## TAFT KNOLLS III JSP16-67

Consideration at the request of 25150 Taft Road, LLC for Preliminary Site Plan With Open Space Preservation Option, Site Condominium, Wetland Permit, Woodland Permit and Stormwater Management Plan Approval. The Subject Property is located in Section 22, South of Eleven Mile Road and East of Taft Road and is Zoned R-4 (One Family Residential). The applicant is proposing to construct up to 15 unit single-family residential development (Site Condominium) utilizing the Open Space Preservation Option.

**TO:** CITY COUNCIL  
**THRU:** BARBARA MCBETH, AICP, CITY PLANNER  
**FROM:** SRI RAVALI KOMARAGIRI, PLANNER  
**SUBJECT:** TAFT KNOLLS III: PROPOSED MODIFICATIONS TO EXISTING CONSERVATION EASEMENTS  
**DATE:** AUGUST 01, 2017

# PLAN REVIEW CENTER REPORT

**S1**  
 SITE PLAN

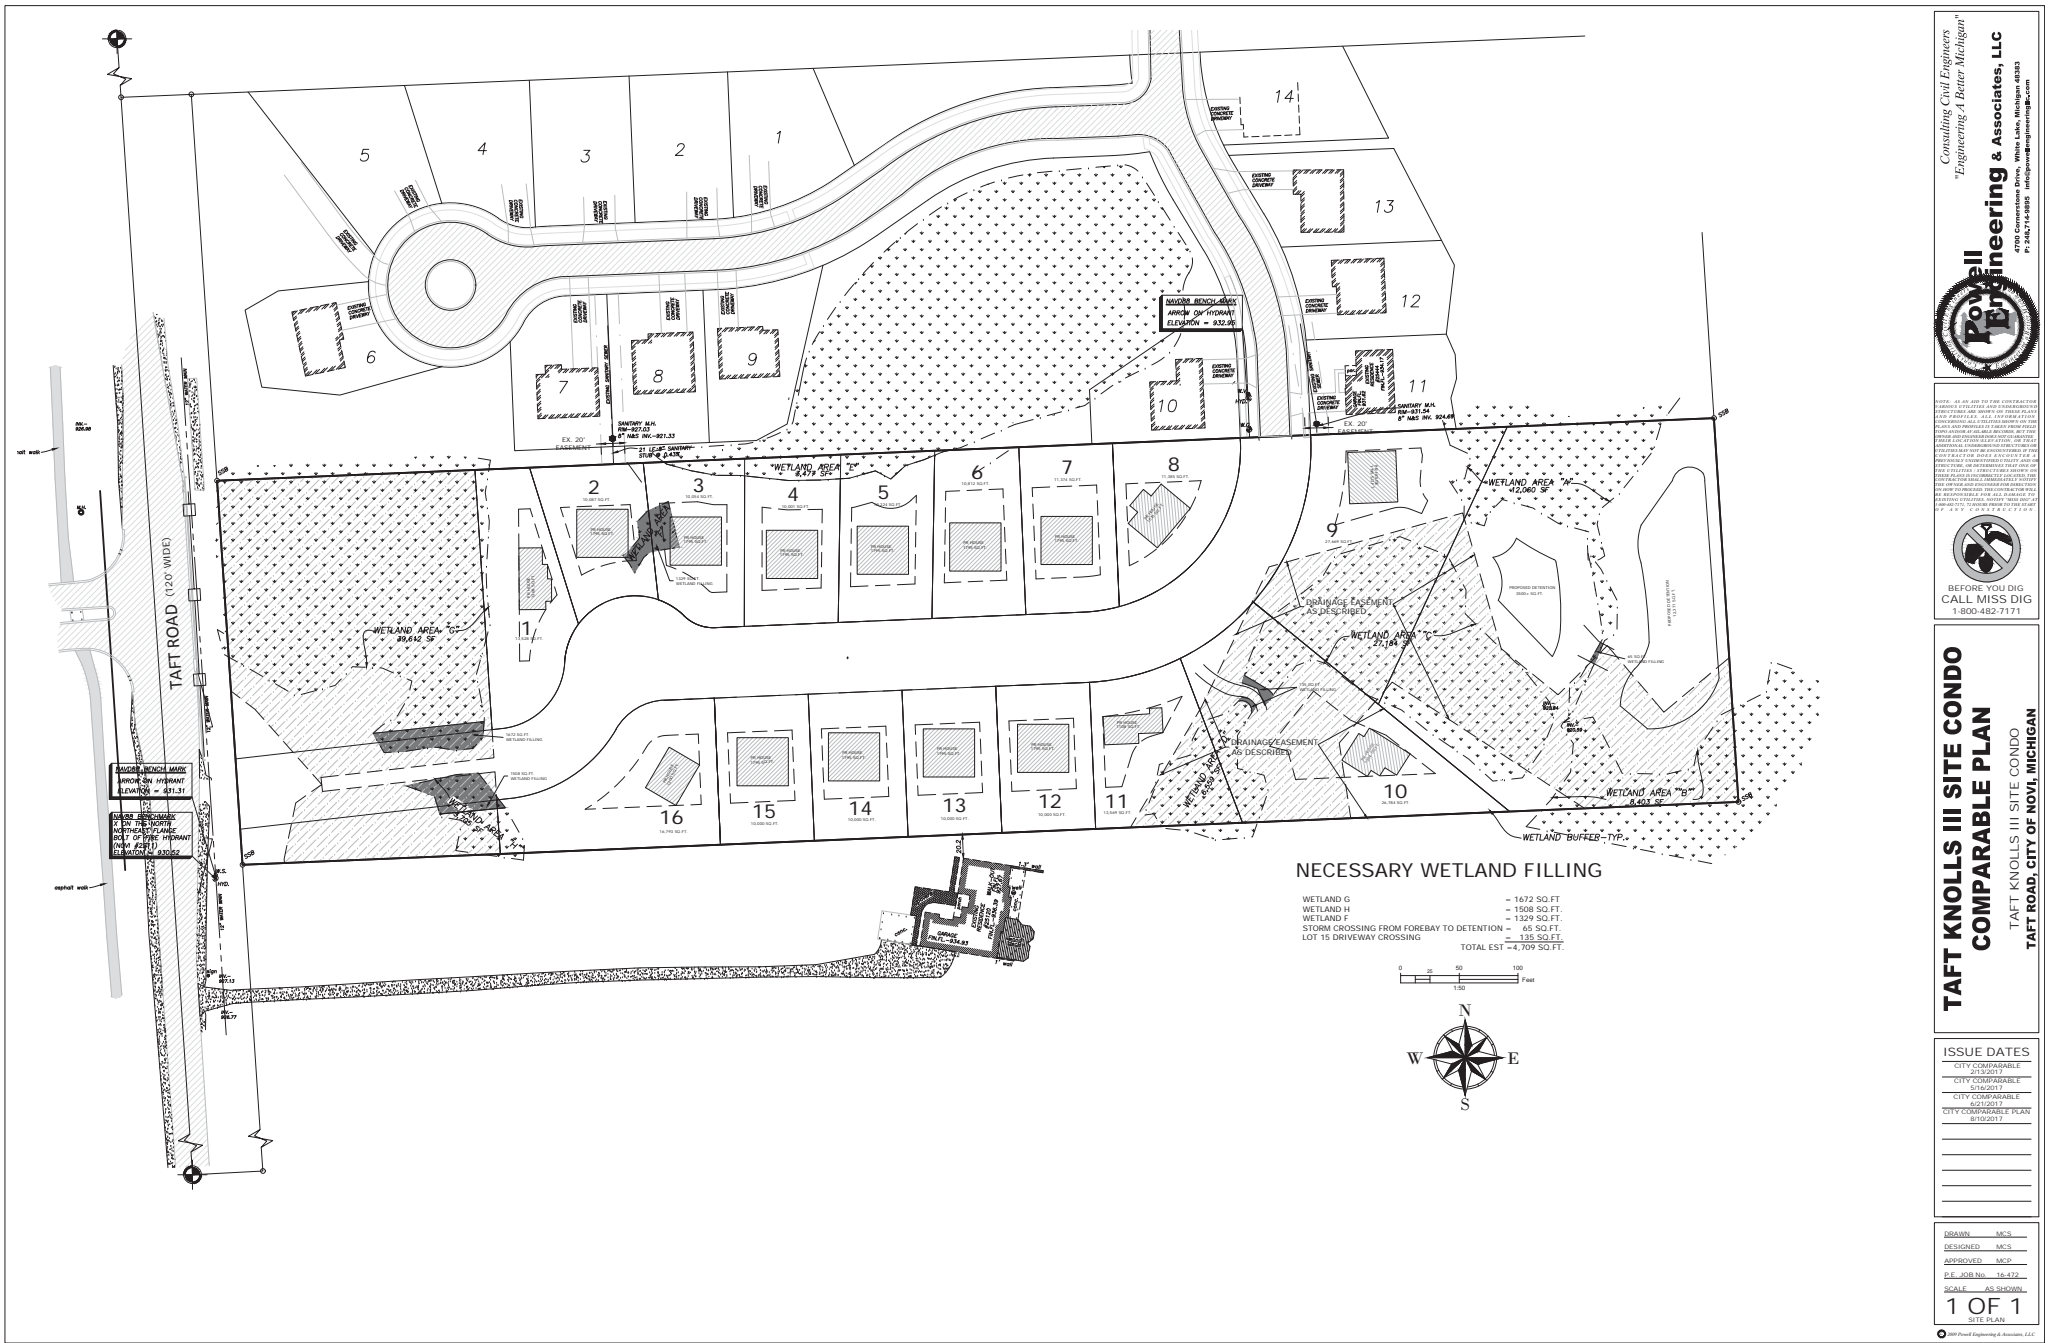
4. Non-Access Greenbelt: A 40 ft. non-access greenbelt is required adjacent to Taft Road. **It does not appear there would be any conflicts with the current layout. Please show and label the non-access greenbelt on the plans.**

3. Sheet S1: The proposed 10 ft. wide water main easement is indicated to be approximately 6 feet onto the proposed public right-of-way. Easement is not necessary if the utility, private or public, is located within the public right-of-way. Also, it does not appear that the shown easement is necessary provided that the water main maintains adequate distance from the right-of-way line. Provide dimension for the water main distance from said line.
4. Provide three (3) signed and sealed sets of revised utility plans along with the MDEQ permit application (1/07 rev.) for water main construction. The Streamlined Water Main Permit Checklist should be submitted to the Engineering Division for review, assuming no further design changes are anticipated. Utility plan sets shall include only the cover sheet, any applicable utility sheets and the standard detail sheets.

4. Non-Access Greenbelt: The nearest development to Taft Rd. other than the entrance drive is more than 250' from the edge of Taft Road, We have labeled Sheet 1 of the site plans with the 40' non-access greenbelt as required.

- A 40' non-access greenbelt will be shown on sheet 1 of the final site plan. There will be more than 250' from the edge of Taft Road to the nearest lot making more than enough space for the 40' greenbelt along Taft Road.

**1. Existing and Proposed Easement Overlay Plan  
(Staff comments)**

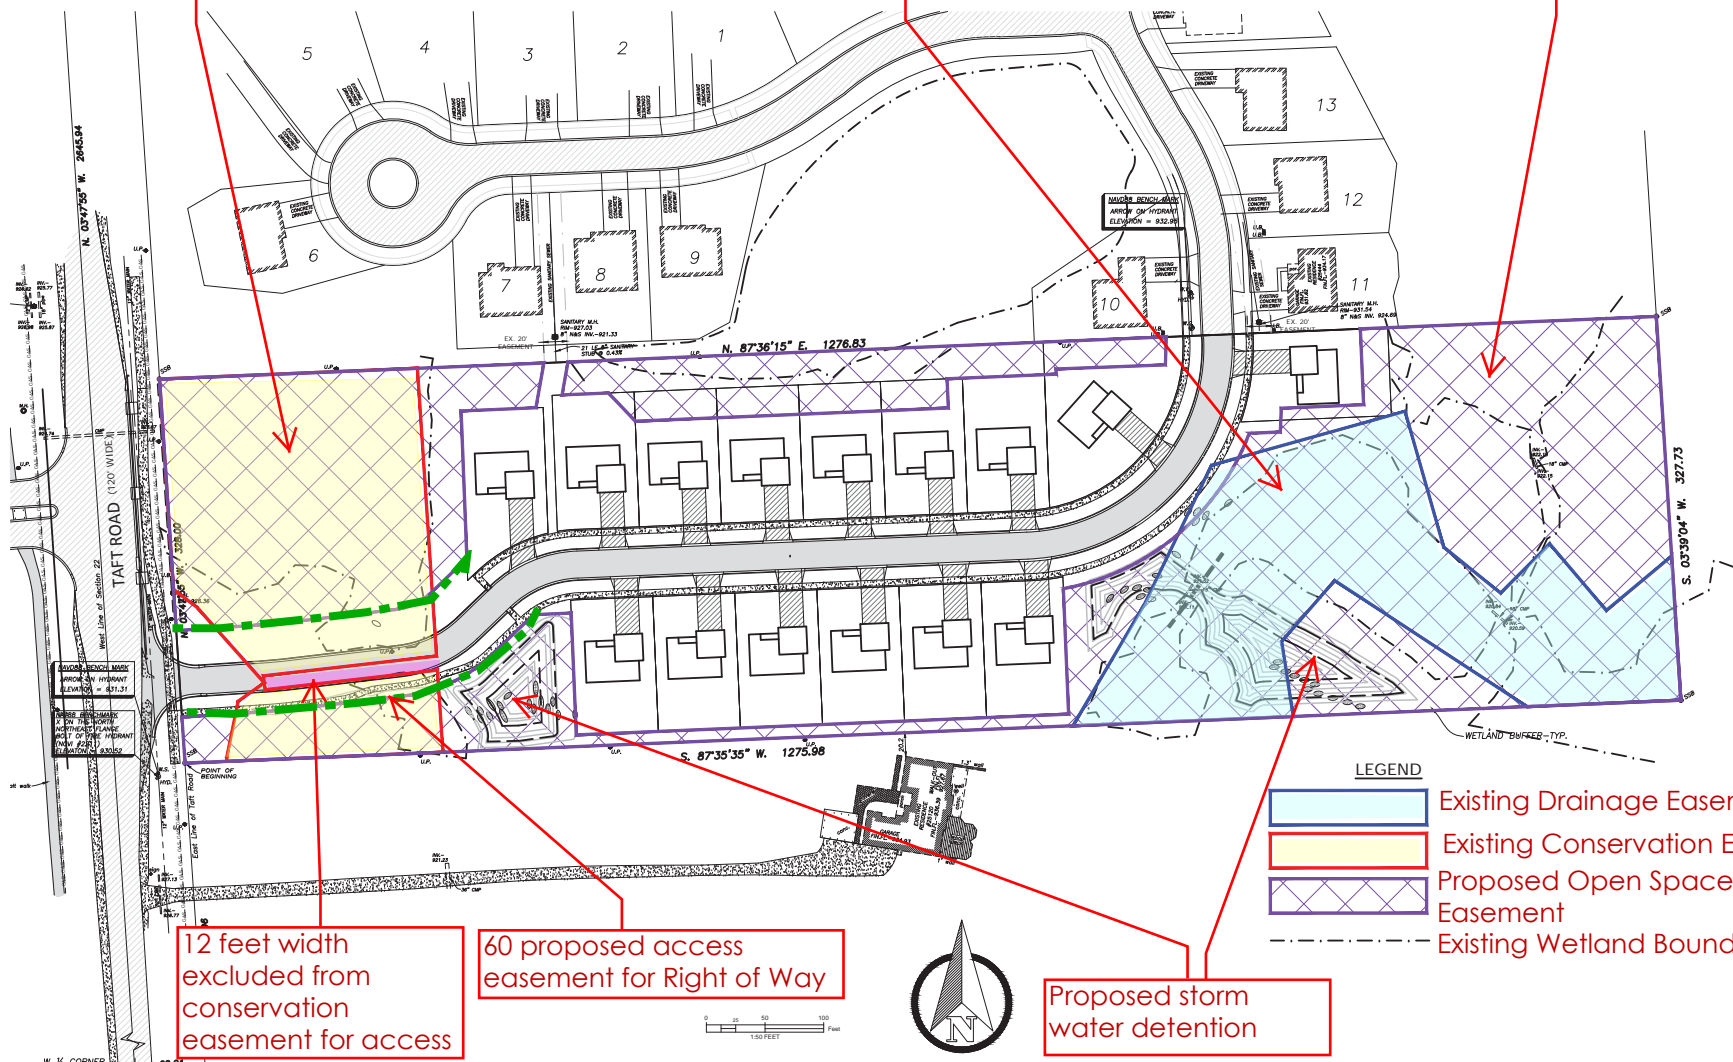
The bonafide plan initially submitted by the applicant did not indicate the existing easements and proposed 16 lots that can be developed per conventional standards. The proposed Open Space Preservation Option indicates 15 lots. However, in light of the recently discovered existing easements, staff has asked the applicant to submit a revised bonafide plan (see attached) indicating the existing easements in order to determine maximum permitted density for the open space preservation plan.

The applicant is essentially asking that the existing easements be modified through the submittal and possible approval of the proposed plan. The Planning Commission is authorized to approve the plan under the ordinance standards. However, in this case, the applicant will also be asking the City Council to modify the existing easements and replace the preservation easement and the drainage easement with one Open Space Preservation Easement. The boundaries of the easements would be modified as shown on the attached exhibit.

**The existing drainage easement is 1.53 acres and preservation easement is 1.51 acres. The applicant is now proposing to dedicate a total of 5.2 acres (total site area of 9.6 acres) of land into open space preservation easement if the land is approved to be developed as proposed. If the submitted plan is approved, with the proposed easement, the applicant is proposing to dedicate an additional 2.16 acres to the City to be preserved.**

1. The site plan is in general conformance with all our Zoning Ordinance, except for a few deviations that are supported by staff. All reviews were recommending approval.
2. Lot 10 as indicated on the bonafide plan cannot be approved due to major conflicts with easements and natural features.
3. Lot 9 and Lot 11 on the bonafide plan includes majority of wetlands in their side yards. However, they can be counted towards the maximum permitted density.
4. The entrance drive can be moved further north in order to reduce the impacts to the wetlands and to include the existing access easement.
5. If there is no need to maintain the drainage easement for any purpose, it might as well be vacated. Staff did not find any history why this easement was created. Staff will look into it further if required.

**2. Bonafide plan  
(by applicant)**

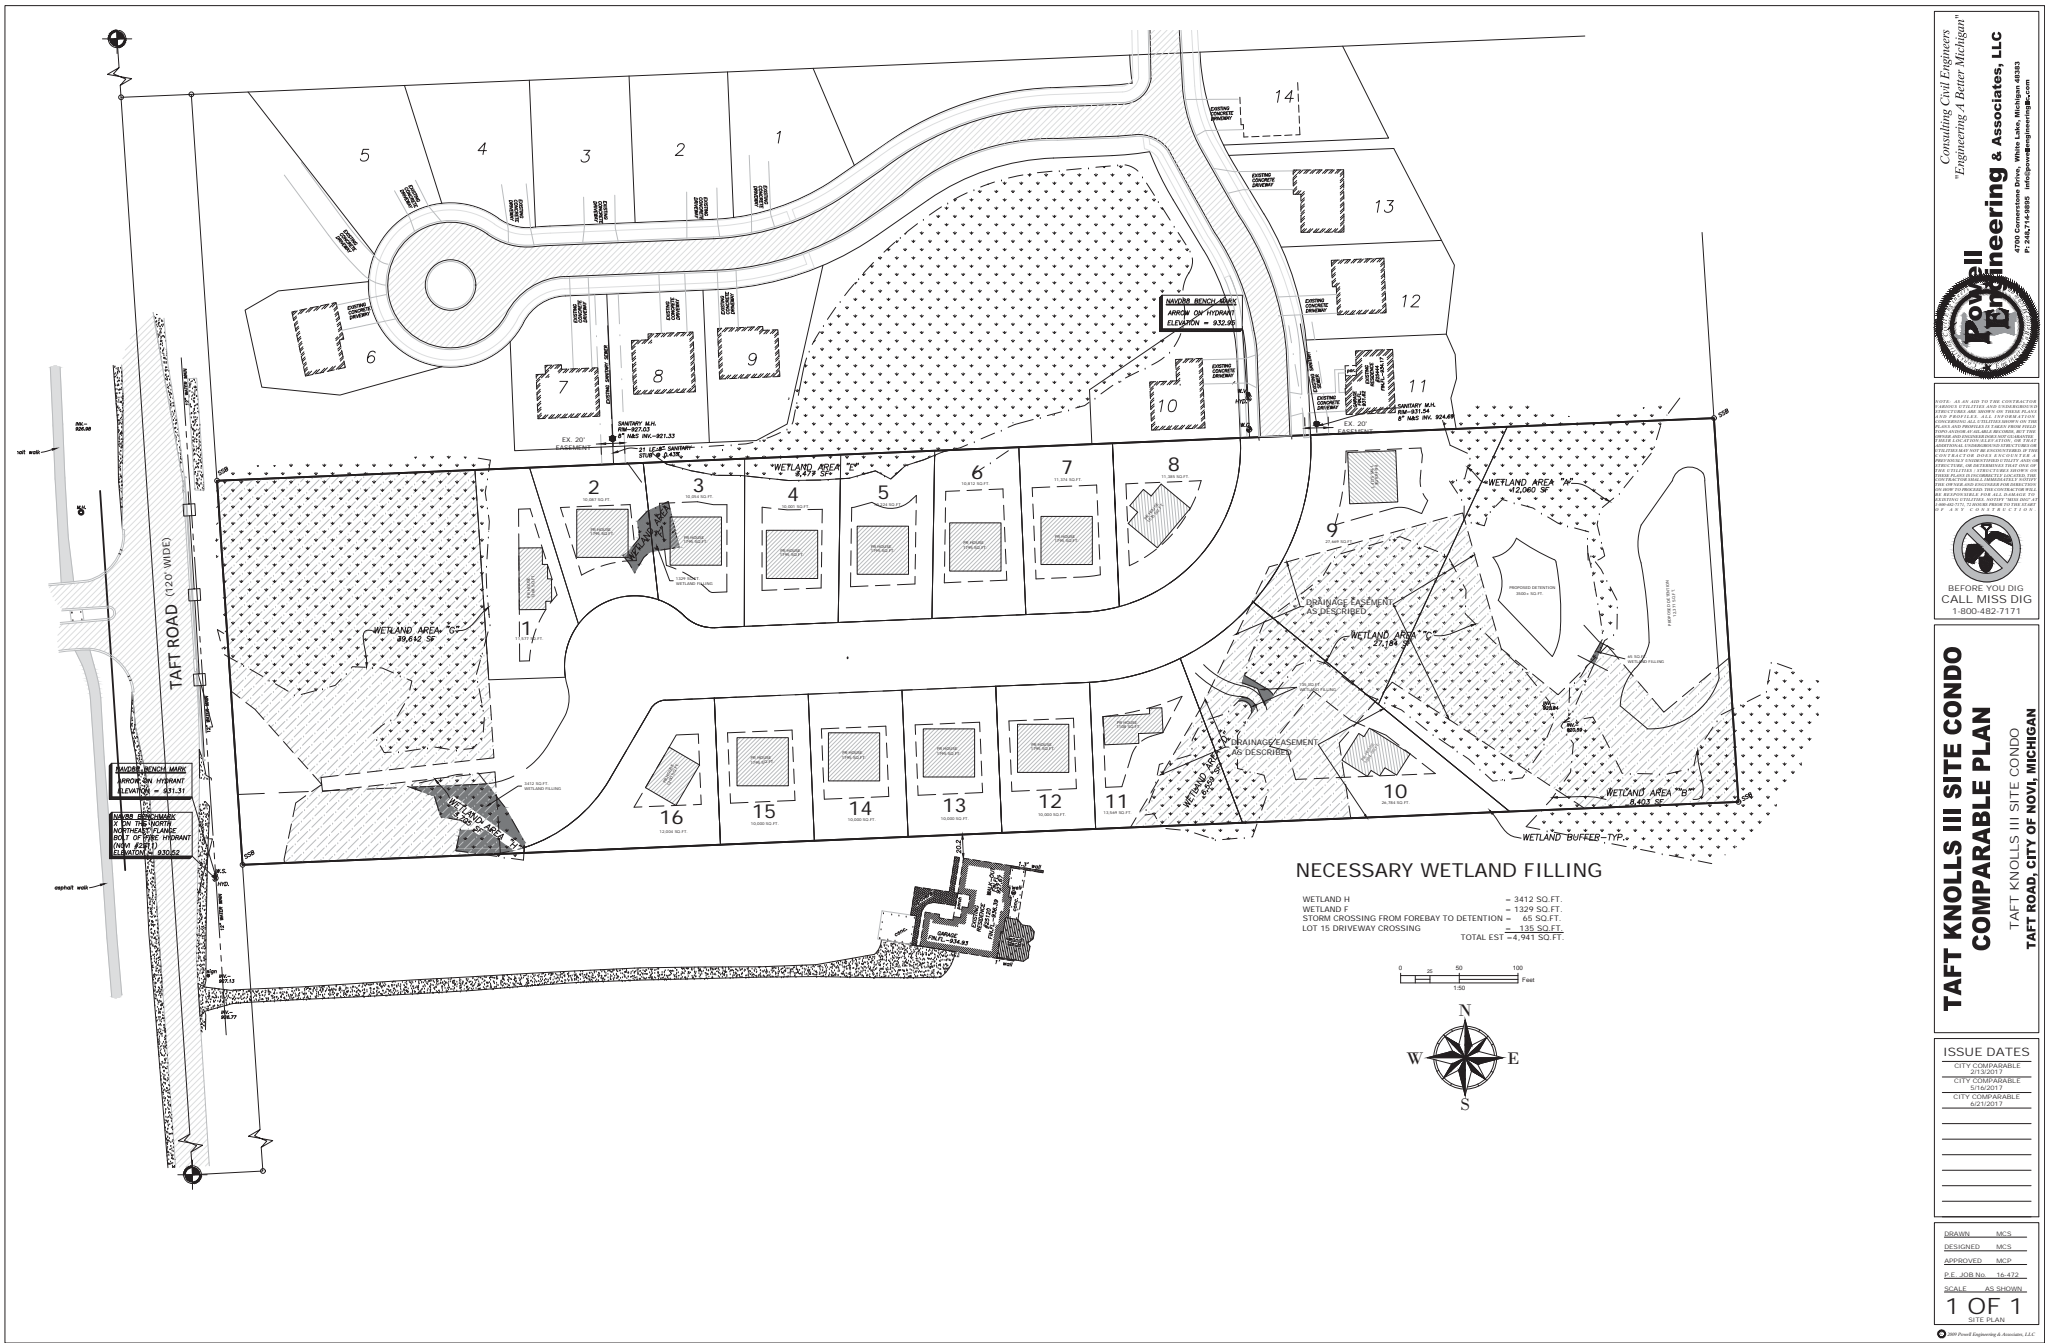
3. **Bonafide plan:** A parallel plan is required, which identifies how the property will be developed under conventional developmental standards. A bonafide plan is included in the plan which indicates 16 lots that can be developed under conventional development standards. The plan included additional details such as setbacks, frontage, conceptual storm water management and wetland fills. **The bonafide plan provided proposes 16 lots. Lot 10 on the bonafide plan does not conform to the Ordinance requirements and cannot be calculated towards the maximum**

number of lots. The proposed road in the plan proposes the least possible impacts to the wetlands. Staff determined that a maximum of 15 lots can be proposed using Open Space Preservation Option.
